Monticello Extended Power Uprate: Response to NRC Reactor Inspection Branch  
Request for Additional Information (RAI) dated March 20, 2009 (TAC No. MD9990)

**NSPM RESPONSE TO REACTOR INSPECTION BRANCH RAIs**  
**DATED MARCH 20, 2009**

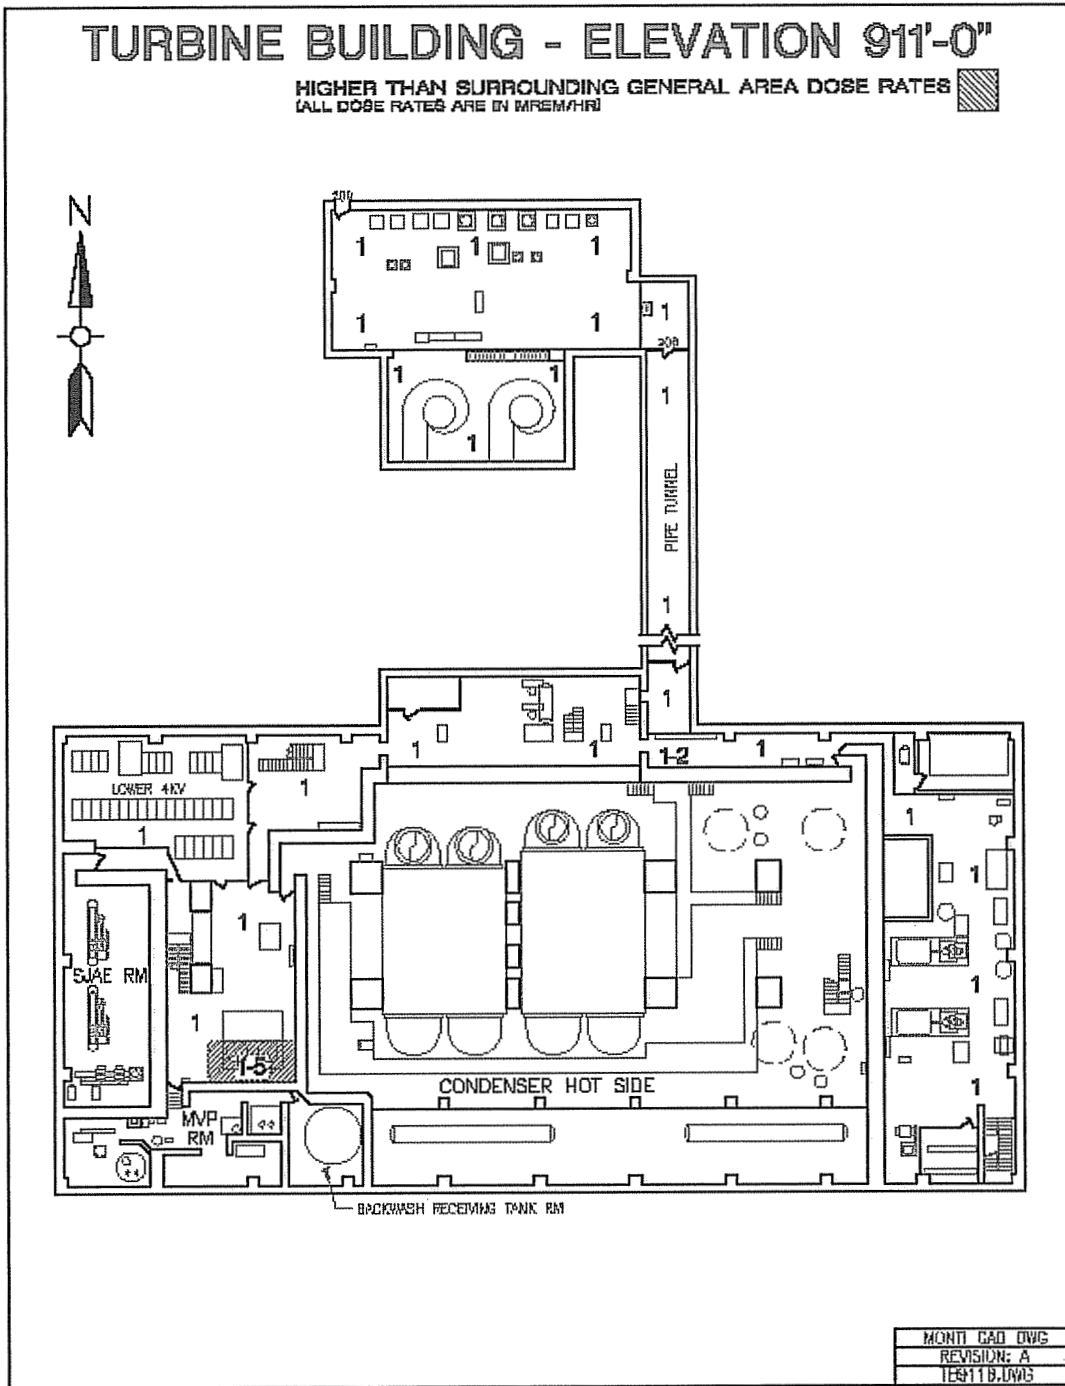
The Safety Analysis Report for the Monticello Constant Power Uprate, dated October 2008, page 2-343, Table 2.10-2, indicates a possible increase in localized dose rates in the Balance-of-Plant (BOP) of up to 1130% under EPU conditions. Verify that these increases do not change the radiation zoning of the BOP spaces.

Post shutdown dose rates are primarily driven by the deposition of activation, corrosion, and fission products in Balance Of Plant (BOP) equipment and piping. The change of deposition sources at EPU is driven by increased moisture carryover, increased activation due to core neutron flux, and increased generation of erosion/corrosion products due to flow increases. Carryover of radioactivity increases as a function of moisture carryover. For this evaluation it is assumed that moisture carryover will increase from 0.05 percent to 0.5 percent at EPU, an increase by a factor of 10. It is also assumed that the generation of erosion/corrosion products in coolant increases in proportion to power (13 percent). A worst case net change is estimated as the product of these two increases (a factor of 1.13 (13 percent power uprate) times 10 (moisture carryover increase) or an 1130 percent increase).

If this worst case increase in shutdown dose rates were to occur, there are four zones in the Turbine Building that could go from a 40 hour occupancy (dose less than 1 mr/hr) to as little as a 5 hour occupancy (dose less than 12 mr/hr). Three zones are locations within the reactor feedwater and lube oil reservoir corridor and the fourth is the feedwater pipe and cable penetration area, which are not normally occupied areas. The remaining areas affected by this potential increase are in steam piping locations in the condenser hot side area which is inaccessible during operation.

These areas are all located on the east end of the 911 foot Elevation, the attached dose map shows the general area dose as 1 mr/hr. Actual operating surveys, taken at full CLTP with normal hydrogen injection flowrates, show the general area dose is 0.2 mr/hr maximum. The increase of 1130 percent would result in a general area dose rate of 2.2 mr/hr, which is still considered acceptable since this is not a continuously occupied area, and it would not affect access to the other normally accessible areas of the Turbine Building.
